FROM: Daniel & Elizabeth Fauxpoint 1505 Rosewood Ave, #7 Louisville, KY 40204 (857) 472-2224 TO: Dr. Jim Mims
Director of Codes & Regulations
Louisville Metro Government
444 South Fifth Street
Louisville, KY 40202

This letter is with regards to 3 building permits (#359225, #359231, #359232) issued by your department on 01/10/2014 to Highland Restoration Group LLC (from here on, HRG) related to the construction of a new building on the lot located at 1505 Rosewood Ave.

Supporting Documentation - Supplement to Letter to Dr. Jim Mims

Figure 1 (Based on excerpt of 2013 building permit application document C3 – Site Layout Plan)

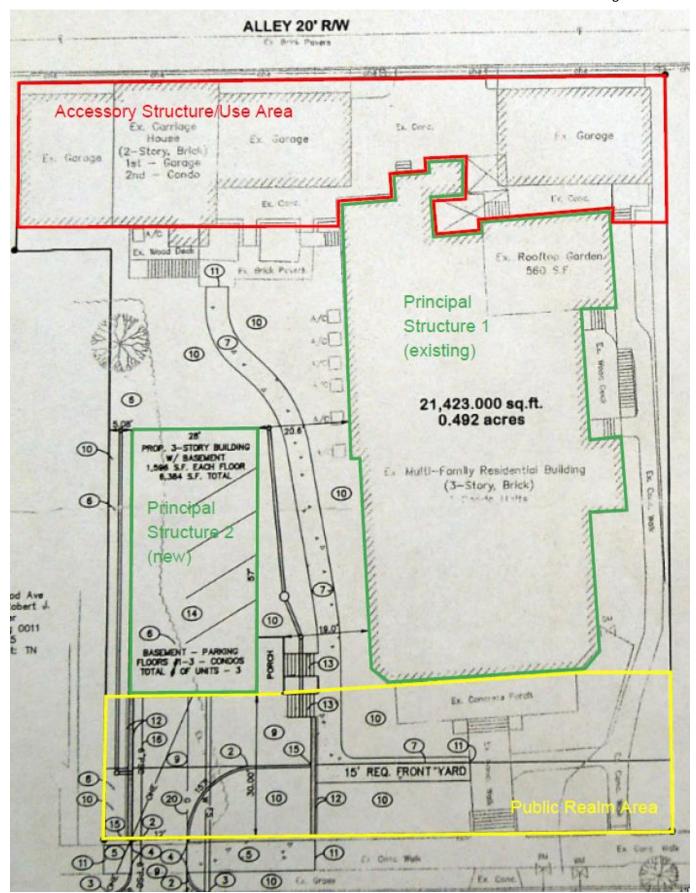
The first observation is that <u>no area on this site fits the strict definition for Private Yard Area</u> since the Principal Structure Area and the Accessory Structure/Use Area share a common boundary.

Figure 2 (Based on excerpt of 2013 building permit application document C3 – Site Layout Plan)

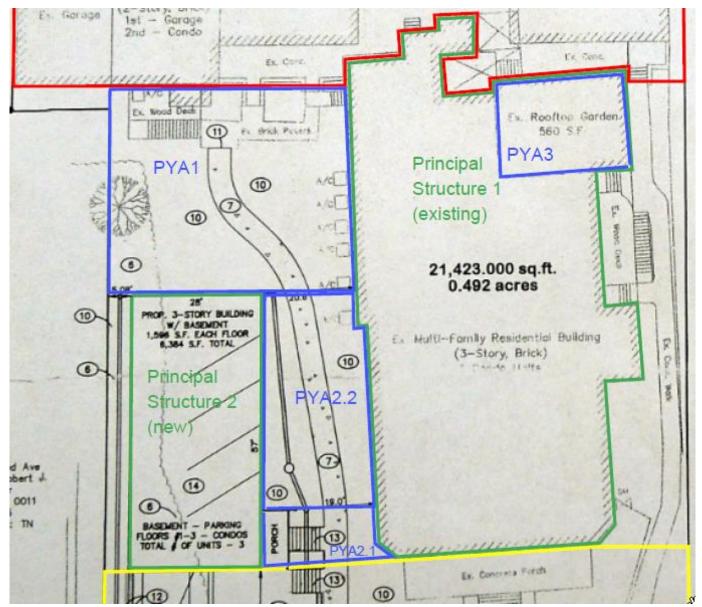
• PYA1: between the back of the new building, the left side of the existing building and the front of the Accessory Structure/Use Area. This surface is technically an encroachment in the Principal Structure Area.

- PYA2.1: between the first twelve feet of right side of the new building (measured from the front façade), and the corresponding section of left side of the existing building. This surface is also an encroachment in the Principal Structure Area, and it does not meet the minimum dimension requirement of "20 feet for a lot of 6,000 sf. or more" found in LDC 2006 5.4.1.D.2 (p. 524) for the following reasons:

- the covered porch cannot be counted as Private Yard Area (LDC 2006 5.4.1.D.1)
 - o there are only 19 feet between the left most side of the porch and the right side of the existing building (and significantly less than 19 feet from the edge of the porch stairs)

- PYA2.2: the remainder of the area between the left side of the new building and the right side of the existing building. This surface is also an encroachment in the Principal Structure Area.

- PYA3: the so-called 'Rooftop Garden', is actually a plain wooden deck, built on top of the existing building roof, and is clearly disqualified by LDC 2006 5.4.1.D.1 (p. 524) which states:

It is clear from these observations, that even a very liberal interpretation of the code leaves the developer with <u>at most</u> the ability to claim PYA1 and PAY2.2 as Private Yard Area. Assuming generous measurements of the dimensions involved, these surfaces represent respectively:

- PYA1: 45 ft by 52^4 ft = 2,340 sf
- PYA2.1: 45 ft by 23^5 ft = 1,035 sf

For a total of **3,375 sf**, a value that is not even close to meeting the requirements set by the Private Yard Area variance⁶ that was granted in 2005 for the entire development project by BOZA.

Note also that there are encroachments both in PYA1 and PYA2.1, in the form of 6 A/C units, covering approximately 32'6" by 4'6", further reducing by approximately 146 sf the area that is really usable as a private yard (see Appendix A).
